1-4 HITCHIN STREET

Fire stopping survey

Thursday 18 July 2024

Prepared For Hendales

UNDERSIDE OF FLOOR

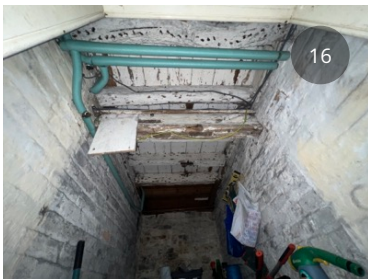
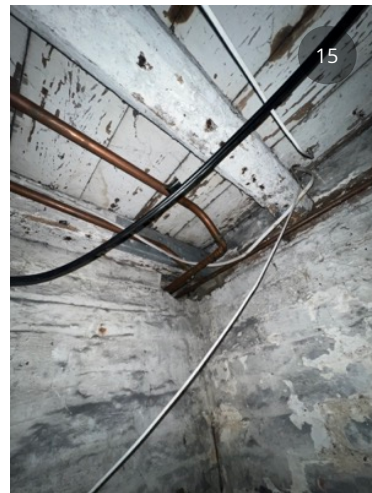
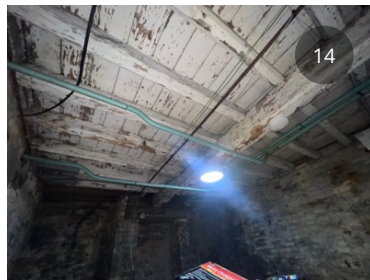
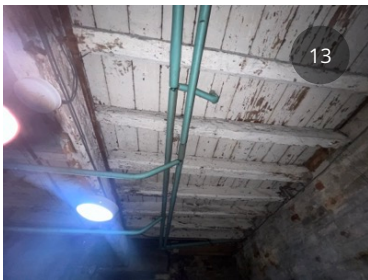
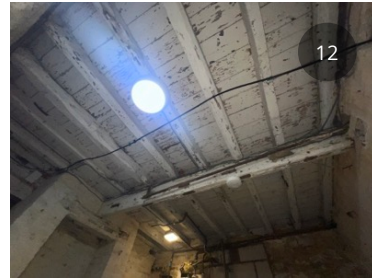
Fire boarding required to underside of stair case and flooring above to provide a minimum of 60minutes fire resistance.

Approximately 10m x 3m

PENETRATIONS

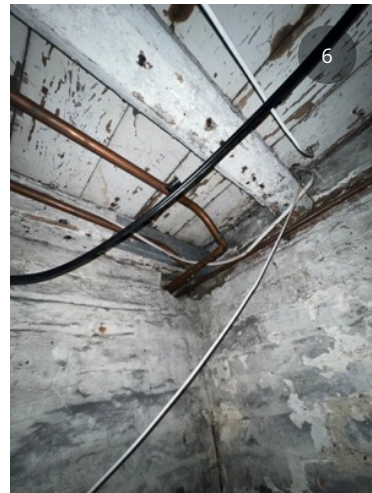
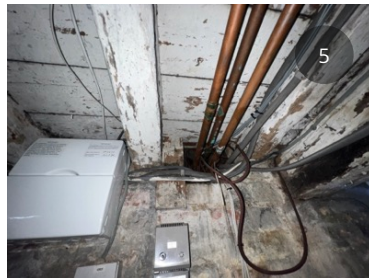
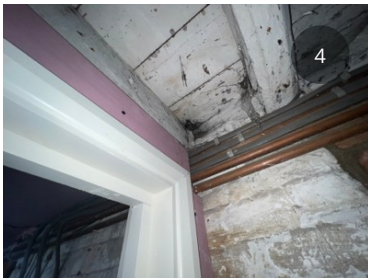
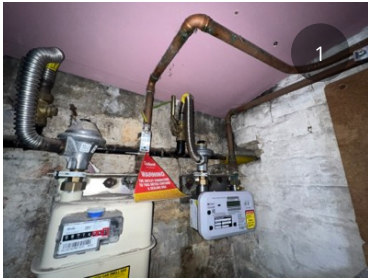
Multiple penetrations through walls and ceiling require fire stopping with ablative materials
